CITY OF
AGOURA HILLS

ACTION DATE:	October 18, 2018
TO:	Planning Commission
APPLICANT:	Architectural Design and Signs, Inc. for LA Fitness 1160 Railroad Street Corona, CA 92882
CASE NO.	AMND-01520-2018
LOCATION:	5075 Roadside Road
REQUEST:	Request for the Planning Commission to approve an amendment to a previously approved Sign Permit, and Variance to increase the dimensions (height) of and add text to one building-mounted sign for LA Fitness; and make a finding of exemption under the California Environmental Quality Act.
ENVIRONMENTAL DETERMINATION:	Exempt from the California Environmental Quality Act (CEQA) per Section 15311 of the CEQA Guidelines.
RECOMMENDATION:	Staff recommends the Planning Commission approve Case No. AMND-01520-2018, the amendment to Sign Permit Case No. 14-SP-040 and Variance Case No. 14-VAR-003(B), subject to conditions, based on the findings of the draft resolution.
ZONING DESIGNATION:	POM-FC (Planned Office and Manufacturing - Freeway Corridor Overlay District)

A RESOLUTION OF THE PLANNING COMMISSION OF THE CITY OF AGOURA HILLS, CALIFORNIA APPROVING AMENDMENT TO SIGN PERMIT CASE NO. 14-SP-040 AND VARIANCE CASE NO. 14-VAR-003(B) TO INCREASE THE DIMENSIONS

Sign A: North Elevation

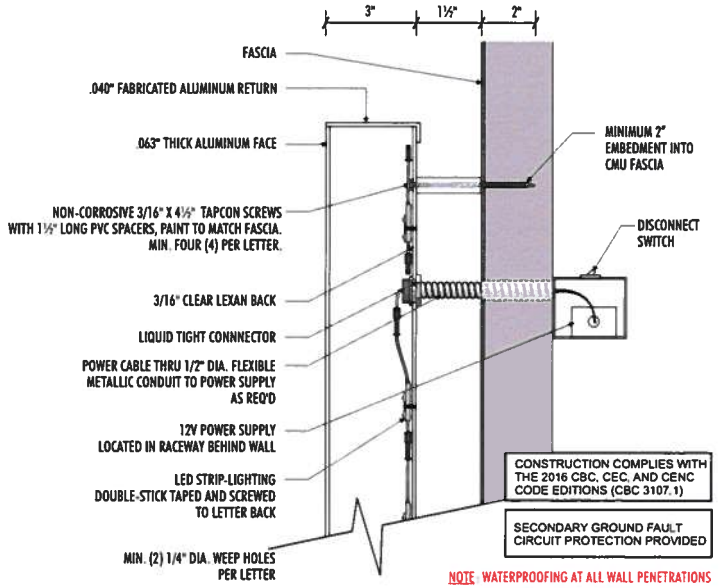
The construction materials used for the letters are different because the north facing sign is halo lit, and therefore, the channel letters are made with a solid, obscure material whereas the south facing sign channel letters are made out of clear plexiglass to let the light through the face. The sign is placed 28 feet above the ground, so it can be seen from the street, but will not add to the lighting of the parking lot.

10. The Fitness building (Building A) sign on the north elevation shall be halo lit and not exceed 75 square feet in area and the sign on the south elevation can be internally lit and shall not exceed 113 square feet.
